Havant Thicket Reservoir, Northern Access Route (EHDC ref 51680/003, HBC ref: APP/20/00990)

Havant Thicket Reservoir – Northern Access Route (EHDC ref 51680/003, HBC ref: APP/20/00990)

Reserved Matters for Phase 1 & various pre-commencement planning conditions

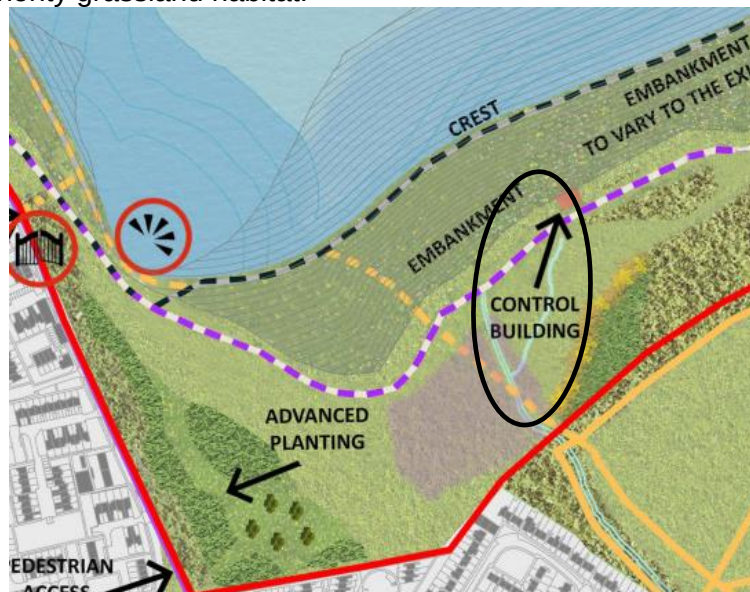
- c) The original Outline Masterplan (HTR-ATK-ZZ-ZZ-DR-L-0001) for the reservoir approved by the LPAs included the **location of a compensation channel water course** from the control house to the Riders Lane Stream in the SW of the site (circled in black on the map extract below). This new watercourse was shown being wholly within the red line boundary. Figure A6 in the LEMP now shows the proposed new channel realigned and joining the stream further south in an off-site location beyond the red line boundary. This is completely inappropriate. The new channel will be designed to take large volumes of emergency drawdown water which will involve the need for very robust engineering of the headworks and channel where it joins the Riders Lane Stream. The construction of the channel and associated structures will have a significant adverse impact on the existing mature off-site oak woodland, including at least one veteran oak tree. It will also adversely impact the access route for grazing animals needed for grassland management, and the new proposed access route to the embankment. The location is in an area where an existing path crosses the stream, where there are problems with anti-social behaviour, including fly tipping. The revised location for the reservoir compensation channel is not appropriate and the LPA should ask for Figure A6 in the LEMP to be revised to confirm the channel will terminate within the P.Water land holding and red line boundary further to the north.

The original Outline Masterplan (HTR-ATK-ZZ-ZZ-DR-L-0001) for the reservoir approved by the LPAs included the **location of a compensation channel water course** from the control house to the Riders Lane Stream, remaining wholly within the red line, in the SW of the site (circled in black on the map extract in Section 2.11c of this document). Figure A6 in the LEMP now shows the proposed new channel realigned and joining the stream further south in an off-site location beyond the red line boundary. This is completely inappropriate. The new channel will be designed to take large volumes of emergency drawdown water which will involve the need for very robust engineering of the headworks and channel where it joins the Riders Lane Stream. The construction of the channel and associated structures will have a significant adverse impact on the existing mature off-site oak woodland, including at least one veteran oak tree. It will also adversely impact the access route for grazing animals

needed for grassland management, and the new proposed access route to the embankment. The location is in an area where an existing path crosses the stream, where there are problems with anti-social behaviour, including fly tipping. The revised location for the reservoir compensation channel is not appropriate and the LPA should ask for Figure A6 in the LEMP to be revised to confirm the channel will terminate within the P.Water land holding and red line boundary further to the north.

This will have the additional benefit of the new channel being able to wet more of the proposed priority grassland habitat.

Bridge railings at Kielder Reservoir

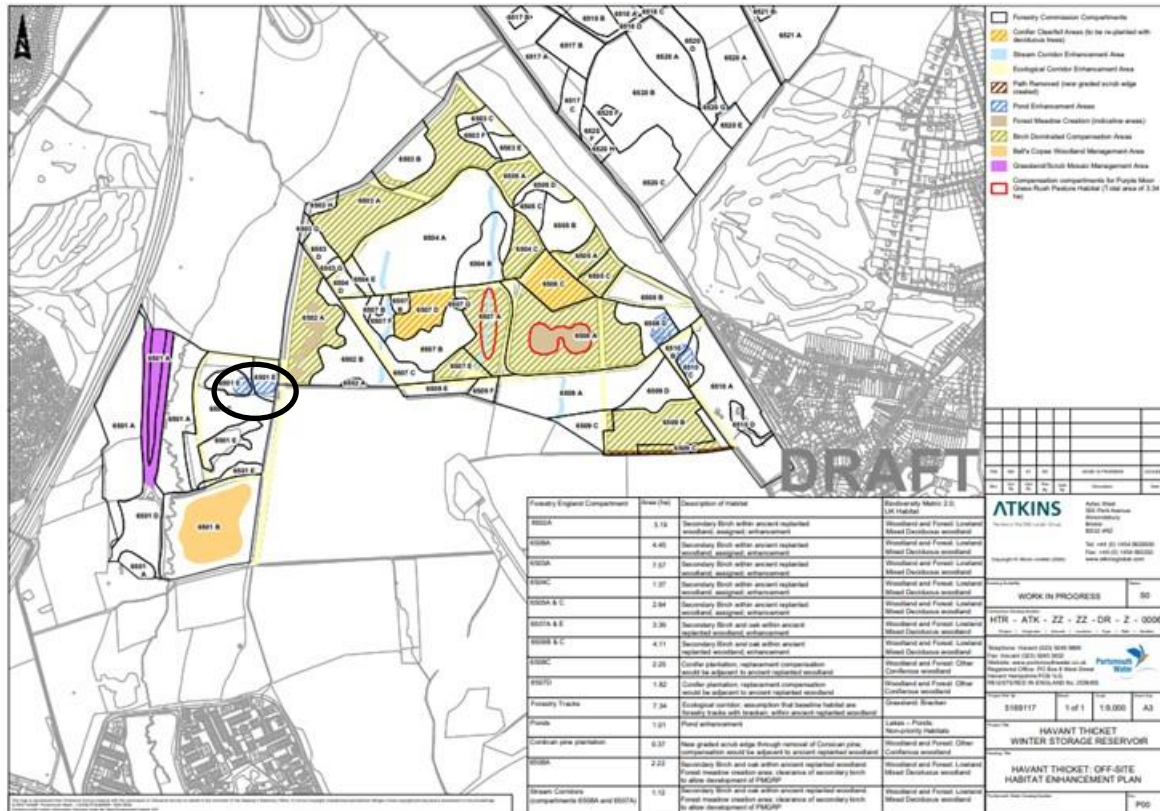
c) Appearance & incorporation of art into the design of the entrance gate; No detail has been provided as to the nature and appearance of the proposed new entrance gate. This is to be the 'gateway' to the new leisure facility and is immediately adjacent to the boundary of the South Downs National Park. It is important that a landmark entrance gateway is provided which is in keeping with the rural character of the area. I would suggest that the applicant provide;

Examples of how metal railings can be used to incorporate art or give a distinct sense of place

Atkins Map for P. Water showing the Bells Copse Pond Enhancement Area – March 2020

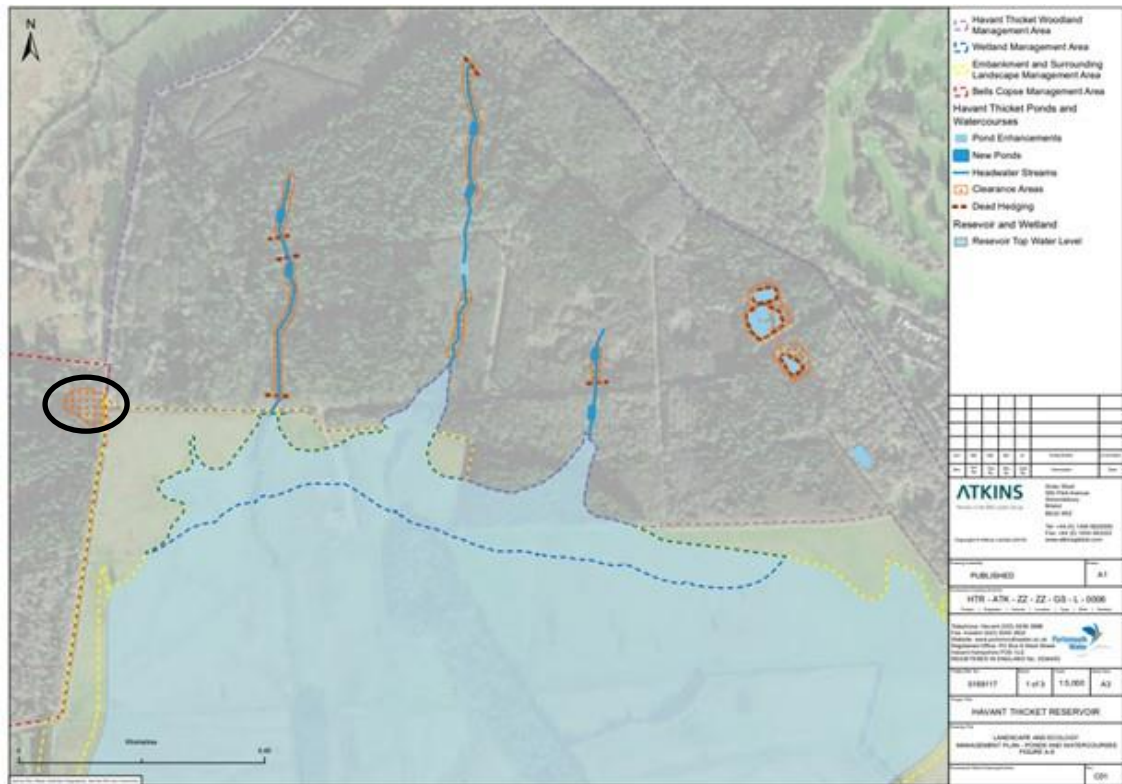
- e) There was to be a **pond enhancement in NE of Bells Copse** which is no longer shown on the LEMP maps, instead Figure A6 just shows some tree clearance. The Bells Copse pond enhancement was shown on previous mitigation maps (Appendix B, Map 1 of this document) and was still on Atkins Figure A3 in the March 2022 draft Biodiversity Mitigation and Compensation Strategy. Section 1.6 and 2.6 of my comments above identify the potential for the northern access road site drainage to be linked to the pond at Bells Copse as a habitat enhancement, helping to keep the existing pond wetter for longer. Given that this is an environmentally led scheme, it is difficult to see why this has not been proposed. The title in Section 7.13 of the LEMP implies pond enhancements only apply in Reach 4, but Section 7.13.2 does make a reference to the Bells Copse Management Area, but what is proposed is not clear. The LPA should require that the pond enhancement at Bells Copse is shown on the LEMP Figure A6 and that the text describes the work planned for the pond, not just clearance off willow trees.

Note: The Bells Copse pond enhancement & additional birch management areas were still shown (as above) on the Atkins January 2022 plan in the draft Biodiversity Mitigation & Compensation Strategy.

I propose that the existing pond at Bells Copse is enhanced to take the additional surface water road drainage, rather than build a separate detention basin. A revised drawing should be requested by the LPA and provided by the developer to show the enhanced pond in order to optimise the wildlife benefit of the scheme.

Figure A6 – Landscape Environment Management Plan (July 2022) – no pond enhancement shown

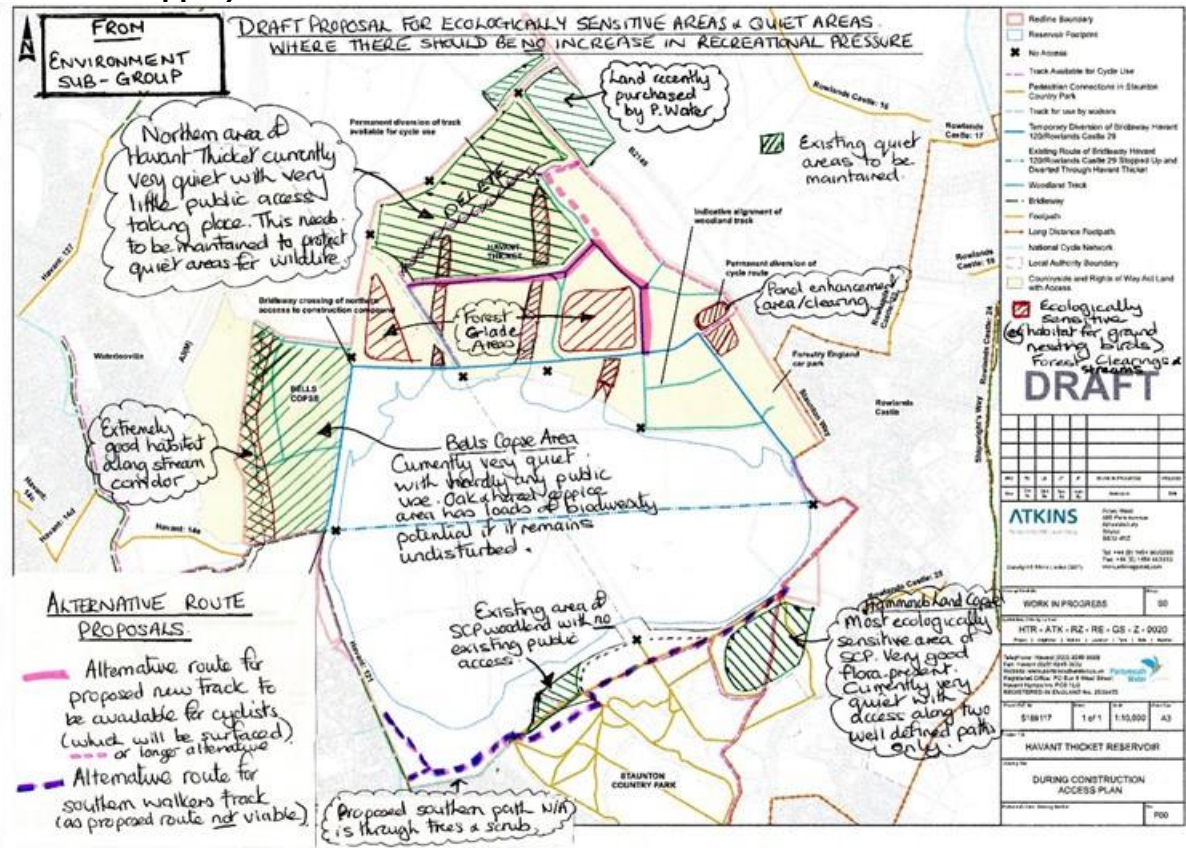
Section 7.13.2 makes reference to a pond enhancement within the willow stand in the NE area of Bells Copse, but this is not shown on Figure A6. The pond enhancement area should be added to Figure A6. As pond enhancements do not just apply to Reach 4 only this should be removed from the title of Section 7.13.
